Idle Fluctuation in Park or Neutral

Service Category Engine/Hybrid System

Applicability

YEAR(S)	MODEL(S)	ADDITIONAL INFORMATION
2015 - 2016	FR-S

Figure 1. Location of Authorized Modification Label on 2015 FR-S

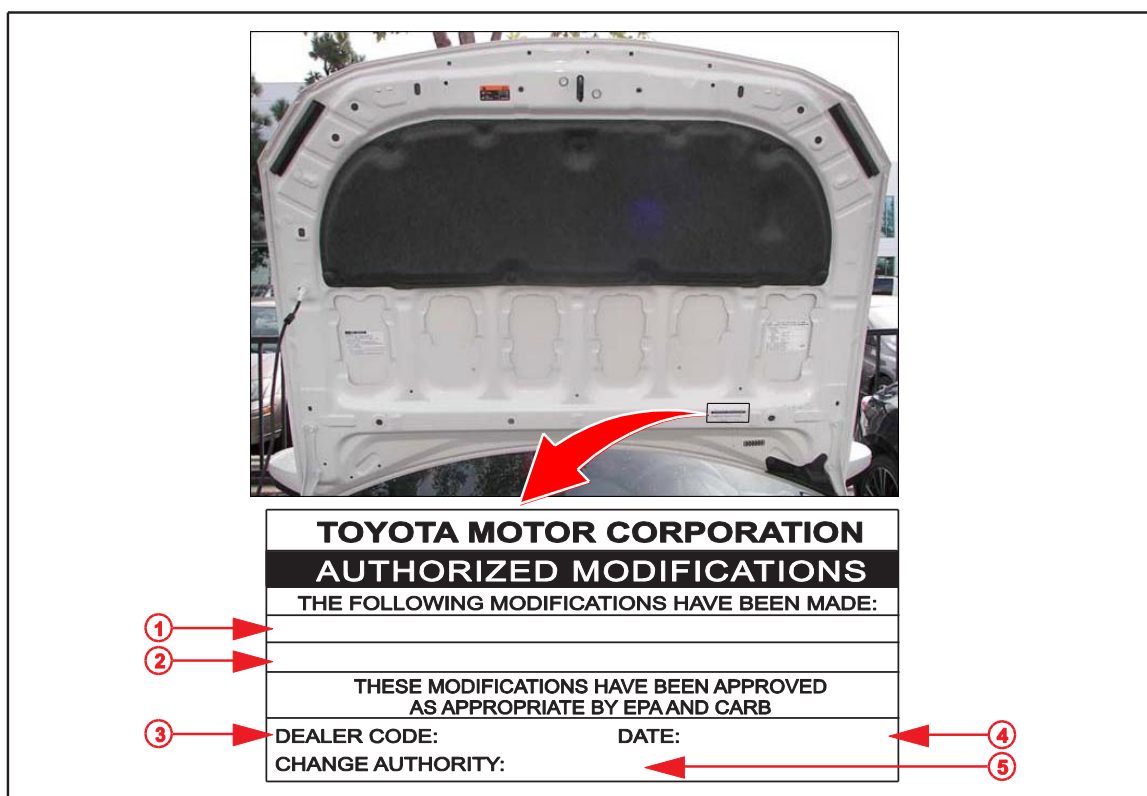
1. Confirm the condition as described in the Introduction.
2. Confirm calibration applicability.
3. Reprogram the TCM.
 - A. Check for the Authorized Modifications Label affixed to the vehicle in the location shown in Figure 1. Confirm if the TCM calibration has been updated. If the calibration ID listed is NOT the latest TCM calibration - go to step 3.B.

(2) Affix the Authorized Modifications Label to the vehicle at the location shown in Figure 1. The Authorized Modifications Label is available through the MDC, P/N 00451-00001-LBL.
